# Access Compliance Report

## Public Rights-of-Way

Intersection ID: 12613	Main Street: E_TRADE_ST	Cross Street: S_BREVARD_ST	Location: SW
ADA ID: EE657E8C3284	Ramp Type: Perp	Initial Pass/Fail: Pass	Overall Compliance: No
Severity Score: 0.25			
Codes/Mitigation Info/Possible Solution		Field Measurements/Component Compliance

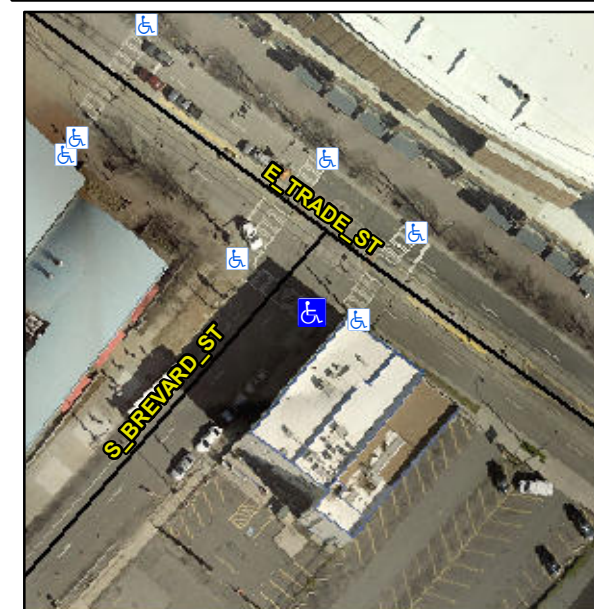
**Not Found, R304.5.3, R304.2.2-Perp, R304.3.2-Para**

Compliance	Description	Data	Compliance	Description	Data
N/A	Ramp Length (in)	44.0	Yes	Ramp Slope (%)	7.7
Yes	Ramp Width (in)	48.0	No	Ramp XSlope (%)	2.1
N/A	Flare Type LT	Sloped	N/A	Flare Type RT	N/A
N/A	Flare Slope LT (%)	7.3	Yes	Flare Slope RT (%)	4.5
N/A	Flare Traversable LT?	Yes	N/A	Flare Traversable RT?	Yes
Yes	Landing Length (in)	48.0	Yes	DWS Provided?	Yes
Yes	Landing Width (in)	48.0	Yes	DWS Contrast?	Yes
No	Landing Slope (%)	2.1	Yes	DWS Length (in)	24.0
Yes	Landing X Slope (%)	1.6	Yes	DWS Full Width?	Yes
N/A	Landing Curb? (Y/N)	No	Yes	DWS Offset (in)	1.0
N/A	Shared Landing?	No			
Yes	Gutter Ponding?	No	Yes	Gutter Slope (%)	1.3
Yes	Gutter Lip Ht (in)	0.0	Yes	Gutter X Slope (%)	1.1
N/A	Painted X Walk1?	Yes	N/A	Painted X Walk2?	N/A
	X Walk 1 Direction	To NW		X Walk 2 Direction	N/A
N/A	X Walk 1 Width (in)	117.0	N/A	X Walk 2 Width (in)	N/A
	X Walk 1 Slope (%)	0.4		X Walk 2 Slope (%)	N/A
	X Walk 1 X Slope (%)	1.7		X Walk 2 X Slope (%)	N/A

**Remove & Replace Entire Ramp.**
